RE: Agency Review Comments and Notice of Possible Exclusion from Minimal Impact Status, Summa Silver Mogollon, Permit No. CA027EM, Modification 23-2, Catron County, New Mexico

Summa Silver has reviewed the comment letters submitted as part of our Part 3 Minimal Impact Exploration Permit Modification 23-2 and Renewal. We have identified the following comments and have the subsequent responses:

Kubla Cubed Road Prism Modeling and Volume Estimate Report

Proposed Bypass Road Segment Drawing Plans

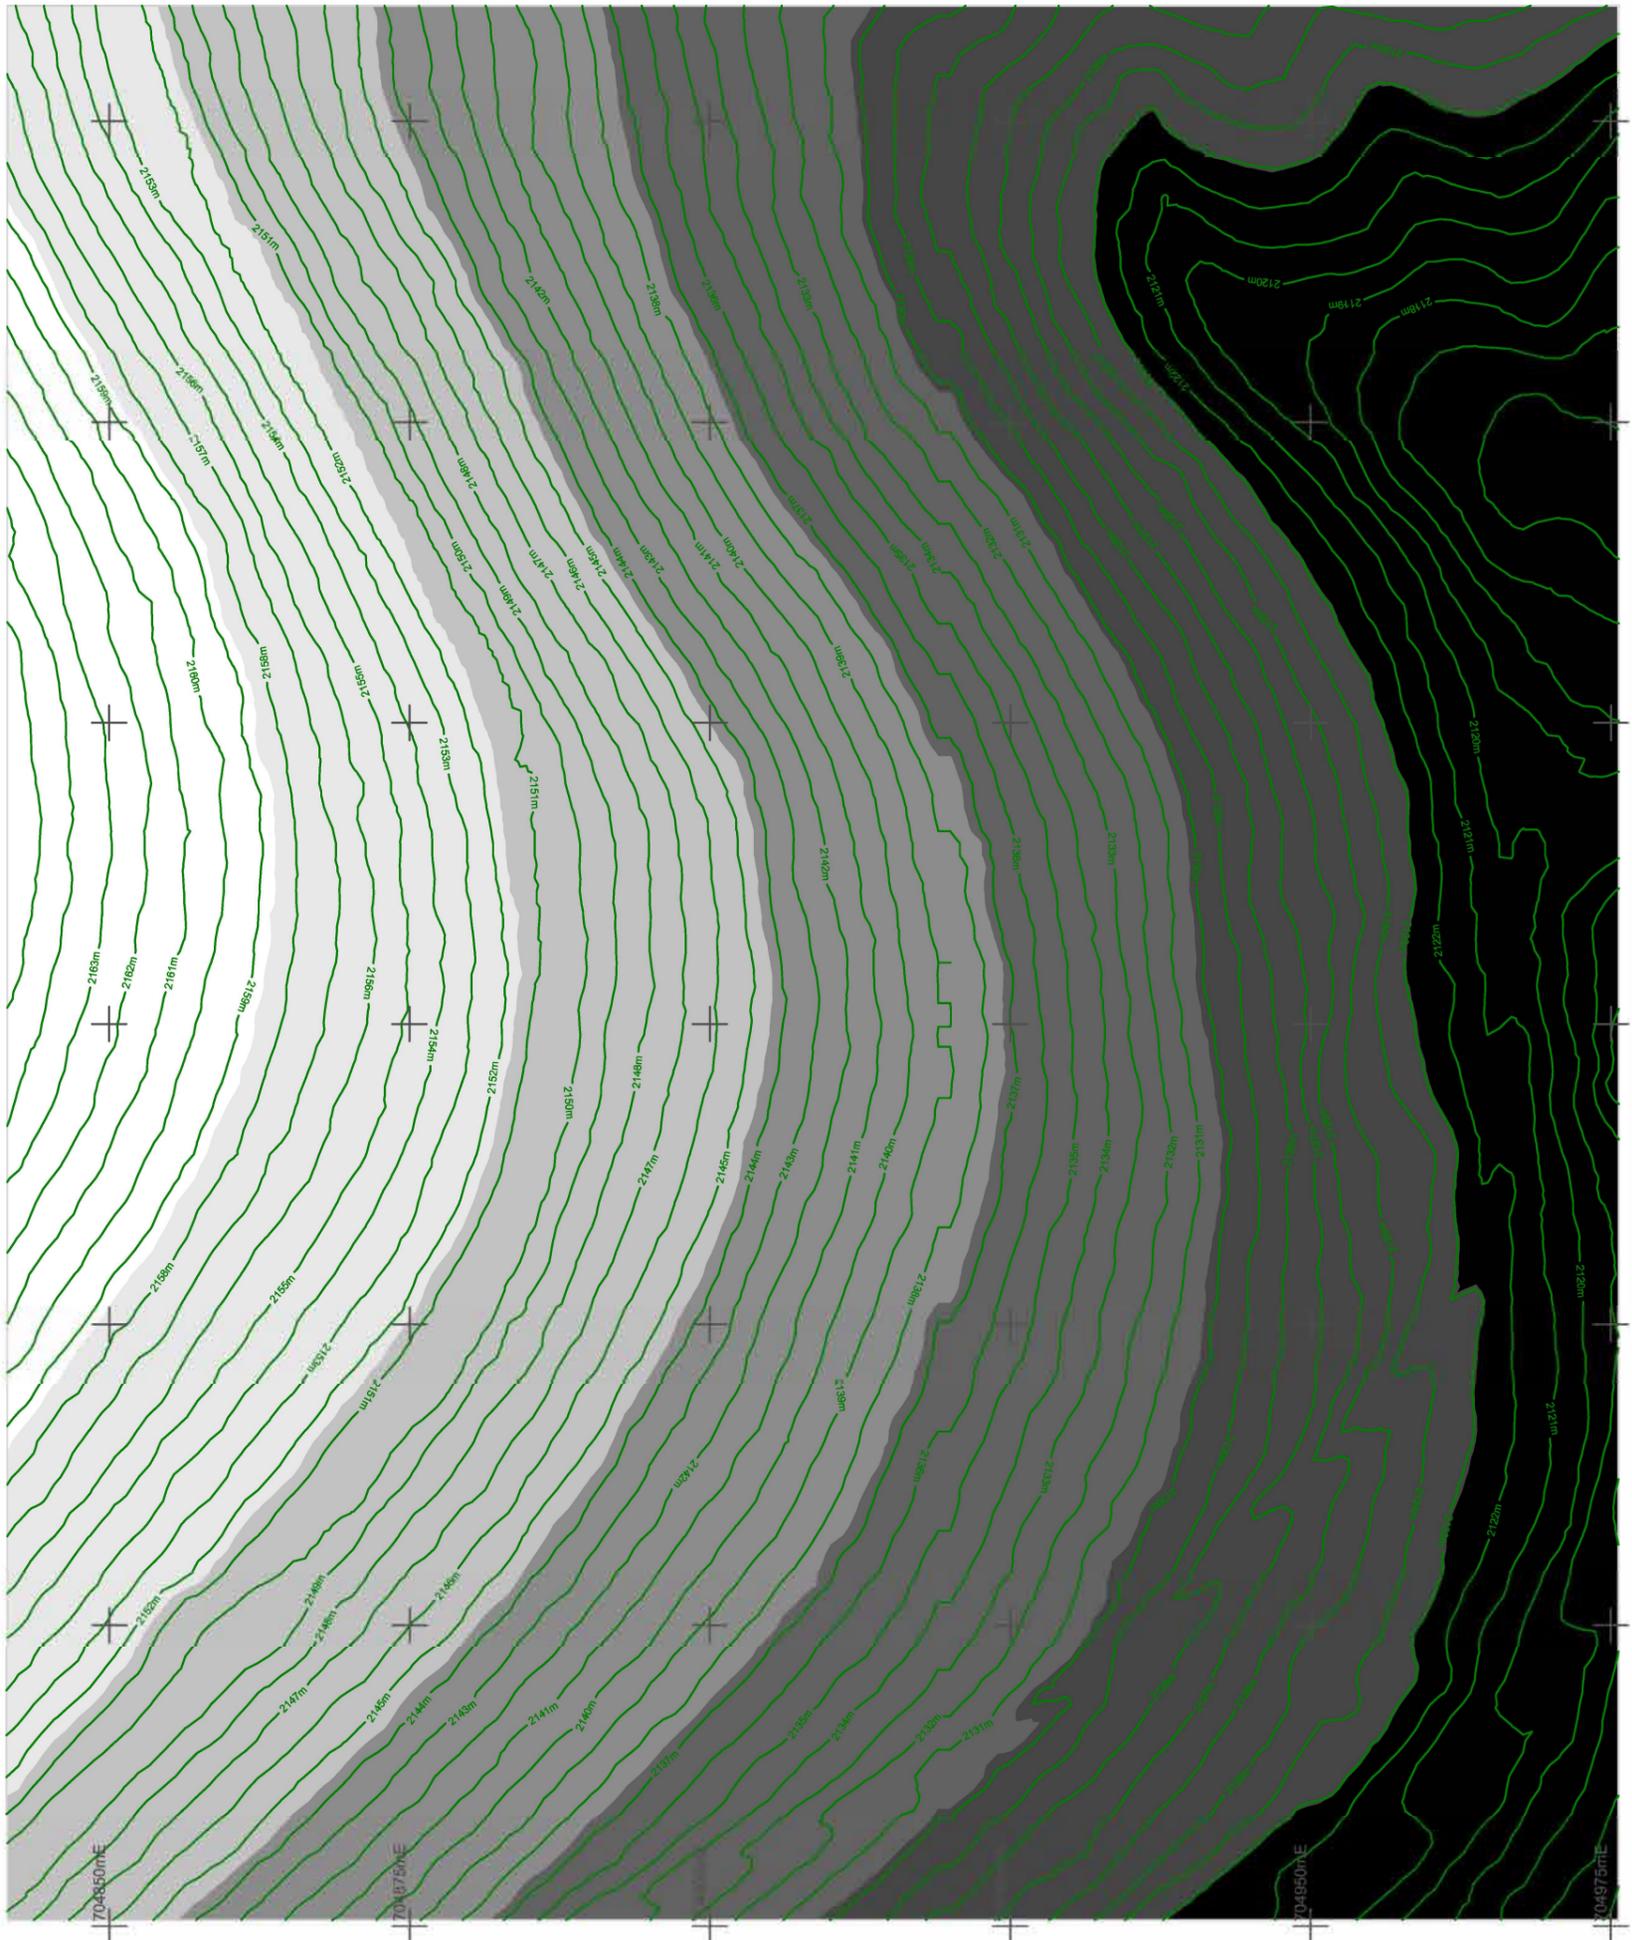
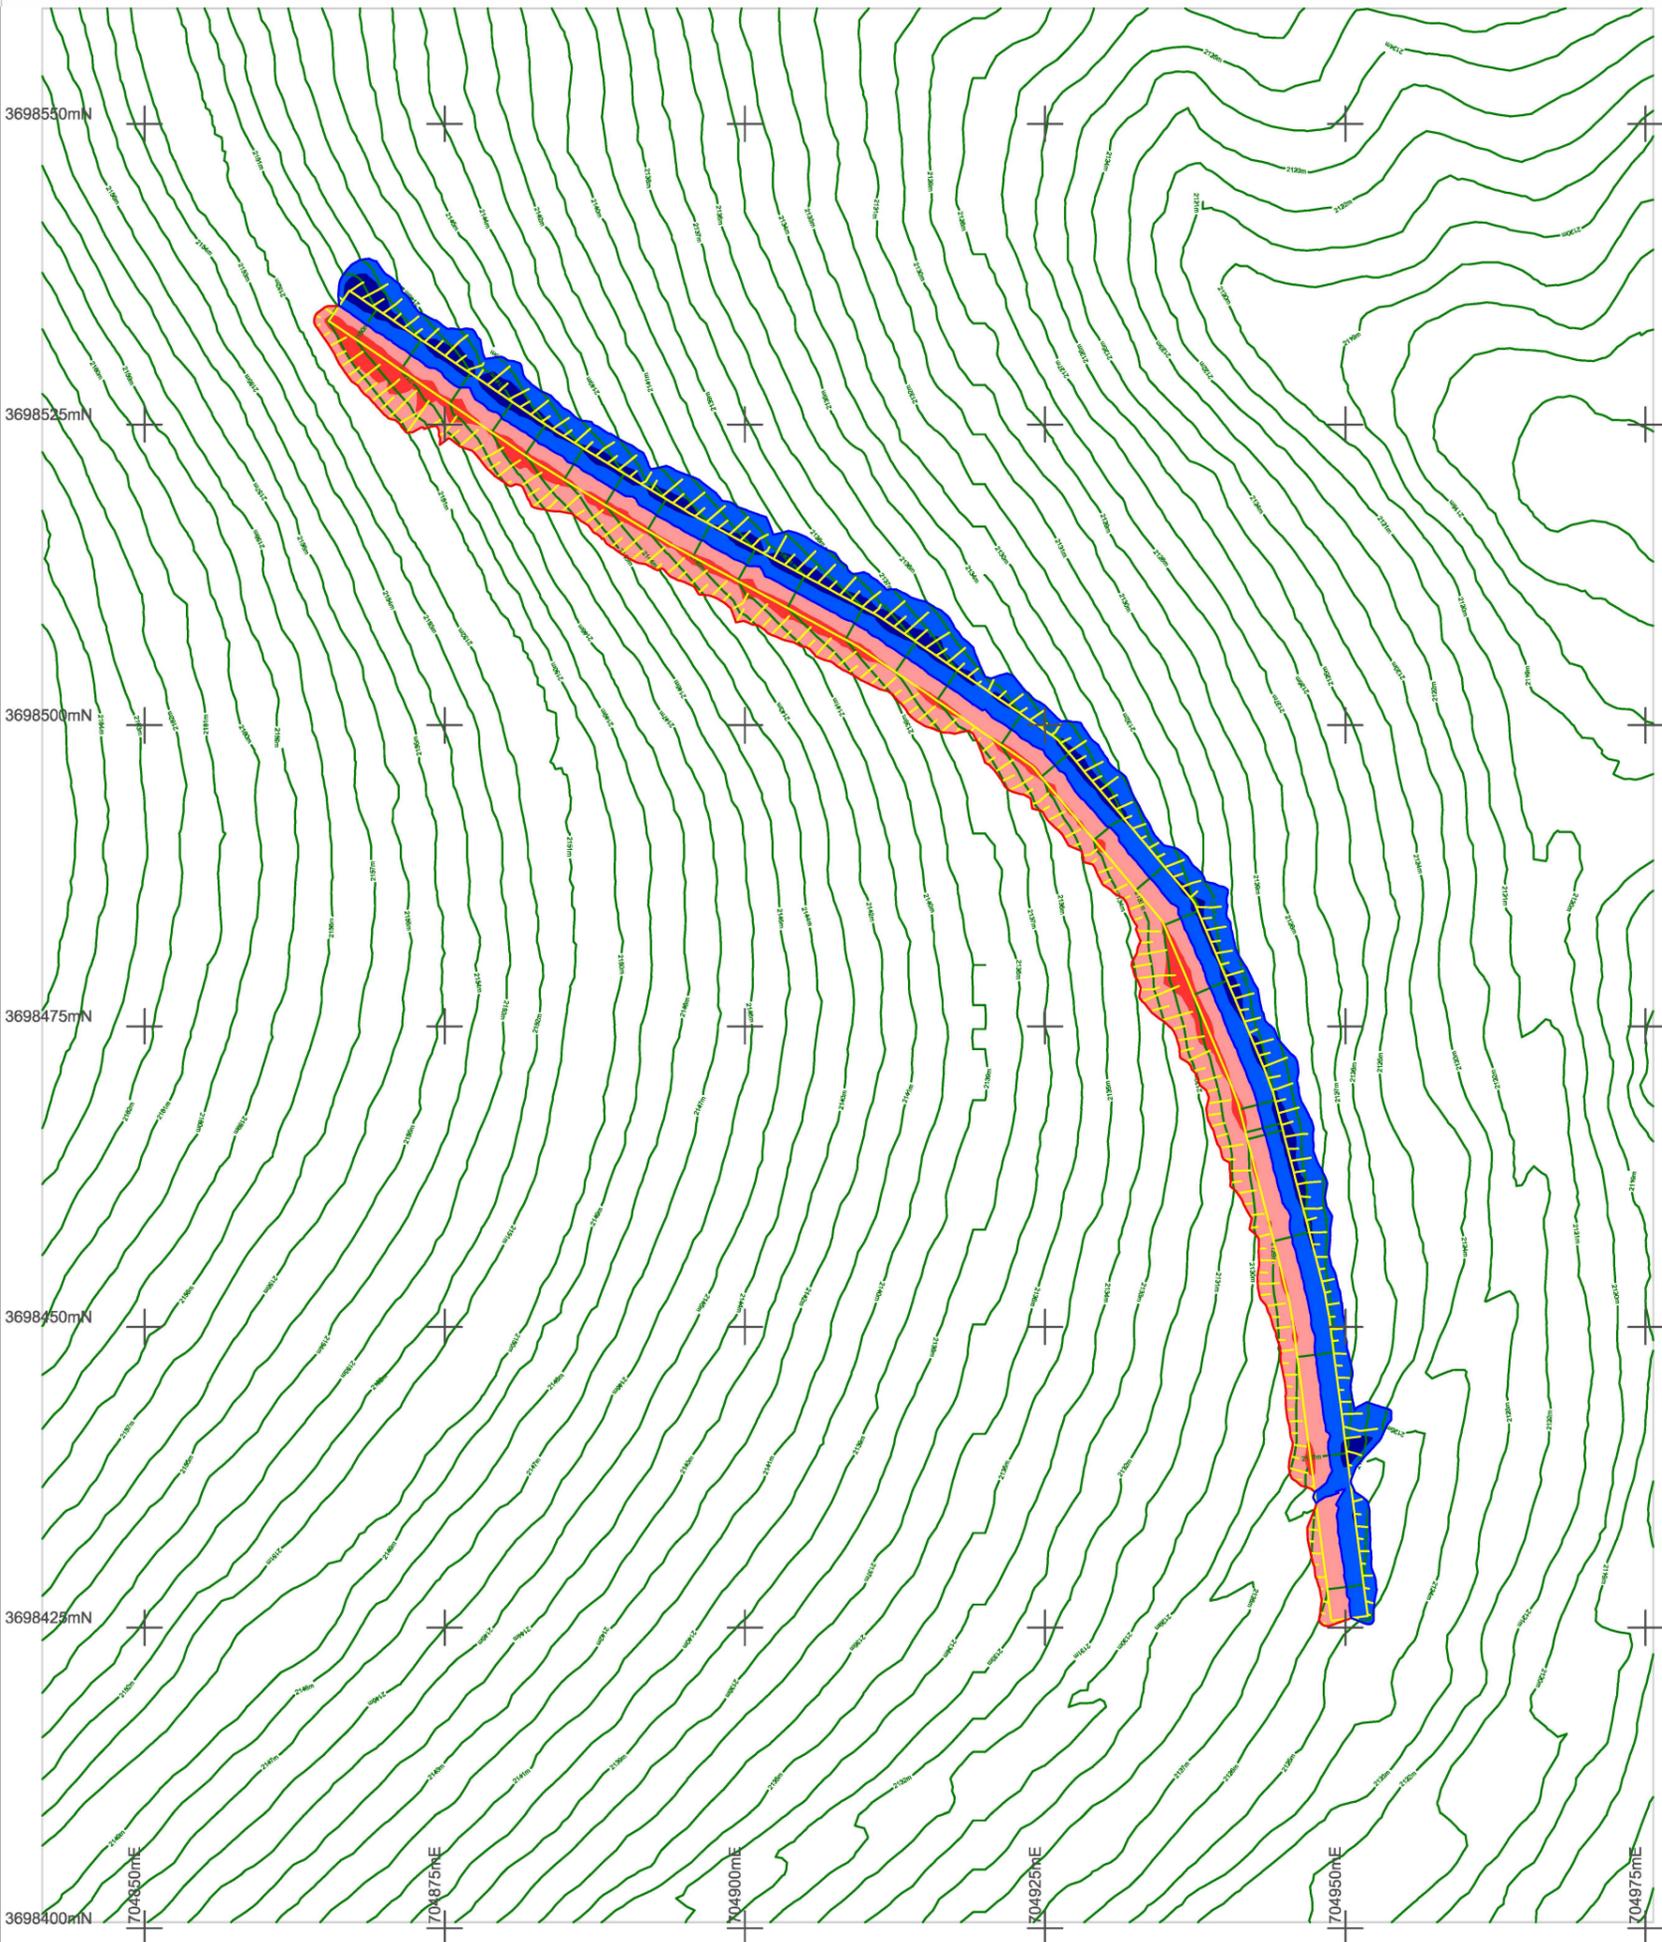
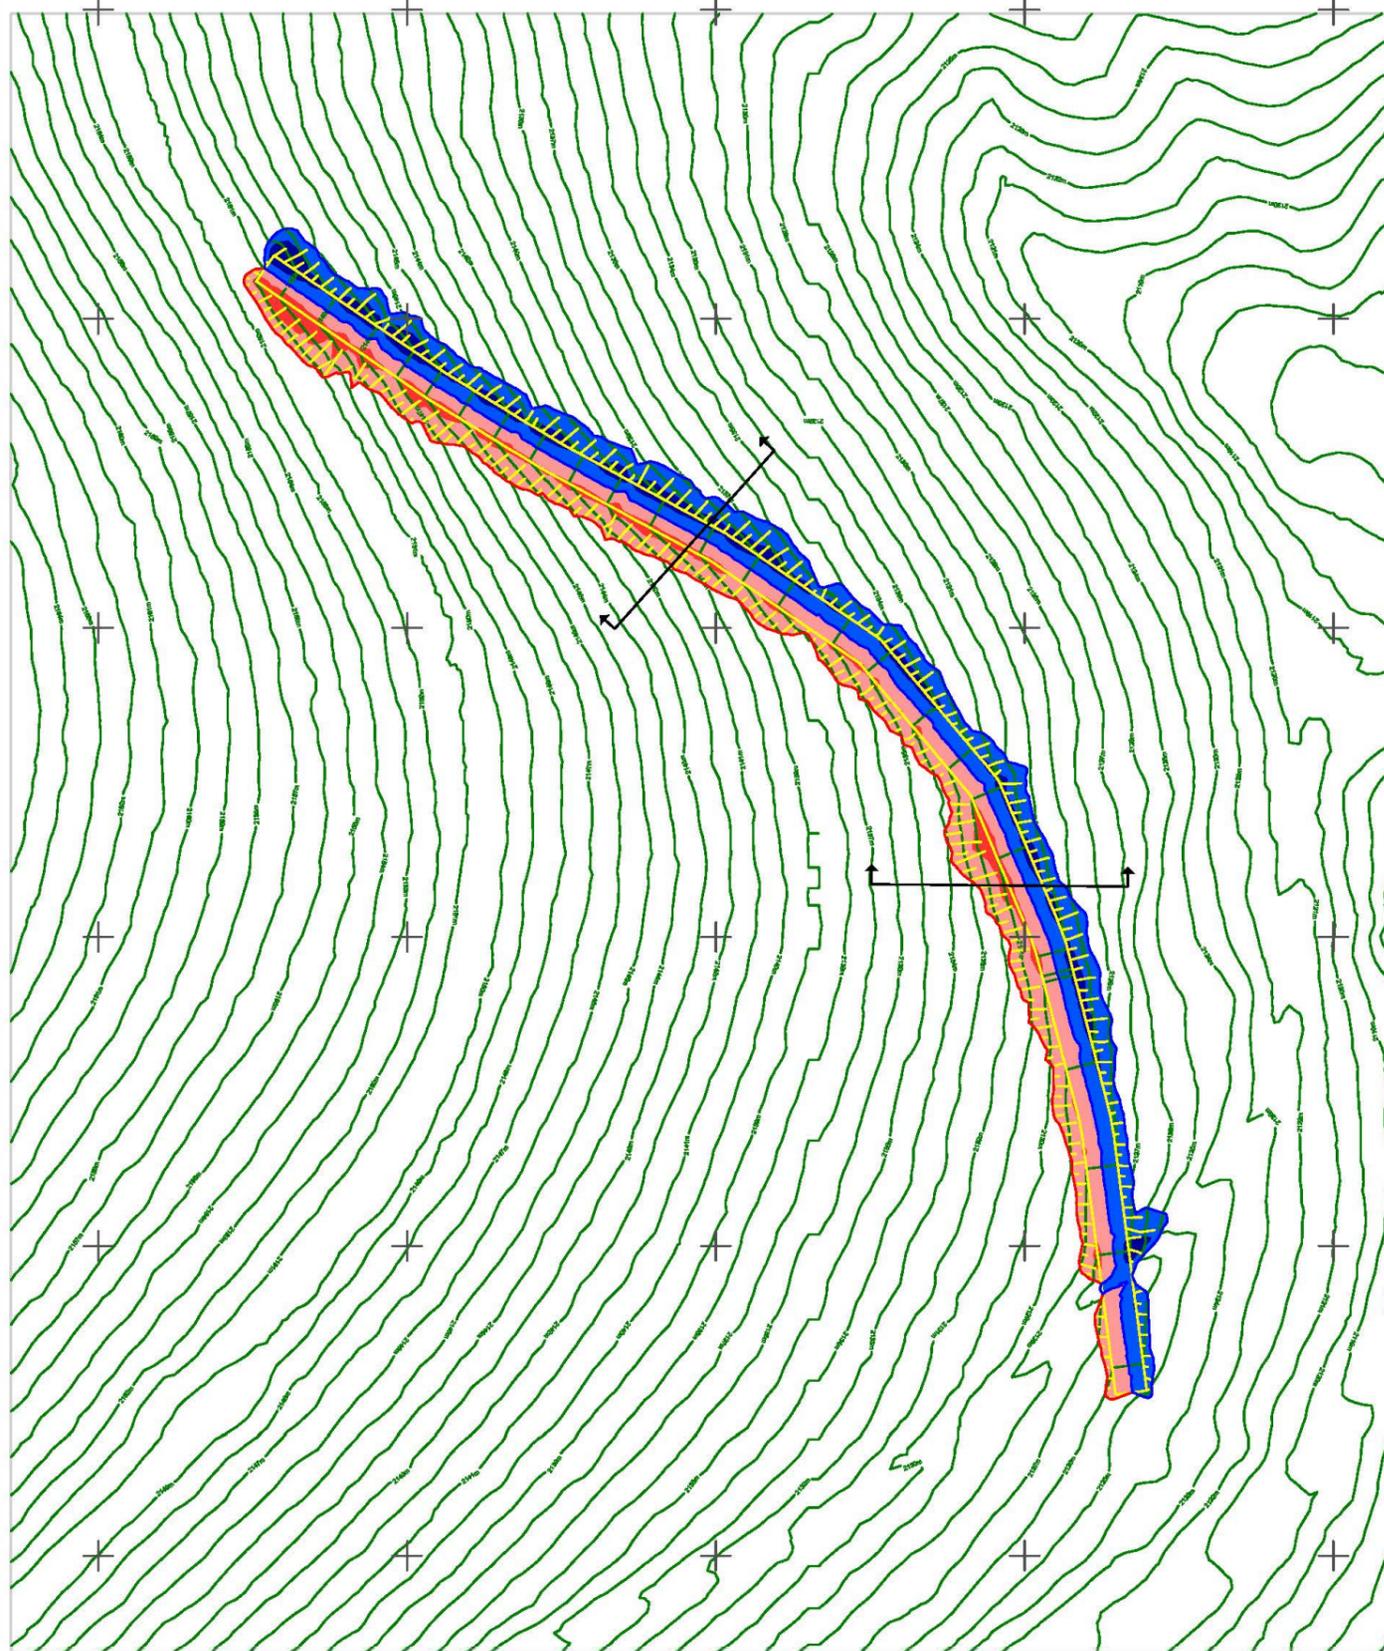
a) The proposed FS 4056O bypass road will travel from existing Drill Pad 11 to an existing roadbed to allow access to the upper drill pad area and require the construction of 581 feet of new road. This portion will be constructed in a wooded area with steep slopes and will likely require cut and fill construction that may extend outside of the 10-foot width listed in the PAP. Please provide more detailed plans for the construction of this portion of the road, including cut and fill calculations, an updated estimate of disturbance area, and any erosion prevention structures that are planned to be constructed.

a.) The FS 056O bypass road proposal, as a whole, consists of two road segments: improvement of 891.58 feet of existing road surface (Segment 1) and construction of 484.52 feet of new road surface (Segment 2). We have completed a full design model of Segment 2, which incorporates a one-meter LiDAR-derived digital elevation model of the existing terrain to calculate the disturbance acreage associated with excavation-and-embankment (cut-and-fill) road construction. The model estimates approximately 168 cubic meters of cut and 162 cubic meters of fill for this segment, resulting in a net fill of six (6) cubic yards. No outside borrow should be required; the excess can be spread as a thin top-dress on the finished running surface or stockpiled for later reclamation. Model-derived calculations and plans are submitted

In summary, a 1V:1.5H cut slope was selected based on observed soil stability conditions along the alignment, which supports minimizing excavation into the hillside while remaining within the stability thresholds recommended by Keller and Sherar (2003). The same slope ratio was applied to fill slopes to improve structural integrity, reduce the potential for raveling or sloughing, and accommodate anticipated operational loads. This configuration also promotes more effective surface stabilization and accelerates revegetation following the completion of field activities.

Given the limited scale of construction, segment two will be built using low-impact techniques consistent with Keller & Sherar (2003) and the BLM/USFS Gold Book (2007). To manage runoff and minimize erosion, rolling dips or water bars will be placed where appropriate based on slope and alignment. Cut-salvaged rock will be applied to any steep fill faces to improve slope durability, and salvaged topsoil will be redistributed along fill-banks to promote vegetation recovery. We trust that this information demonstrates that the bypass road remains within the bounds of a Part 3 minimal-impact modification, while restoring safe and efficient access to our upper drill pads.
